SERVICE BULLETIN

APPLICABILITY: 2020-21MY Legacy and Outback

NUMBER: 12-317-21

SUBJECT: Console Lid Inner Tray Mat- Design Change

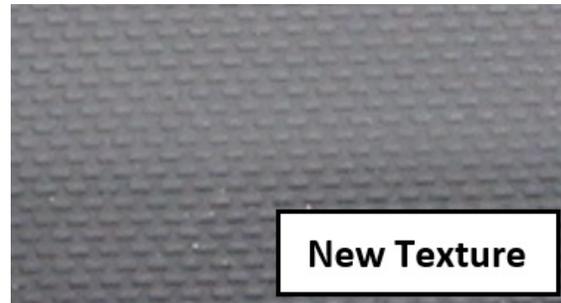
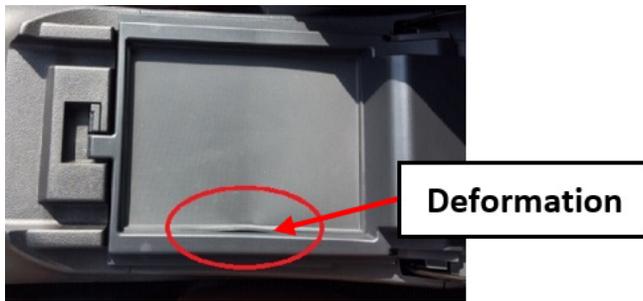
This bulletin announces a change to the mat located in the inside tray of the center console box lid to address concerns of shrinking and deformation. The new mat is made with a revised production process and incorporates an enhanced texture to prevent the condition shown in the photo below.

The new MAT part number is **92177AN021**.
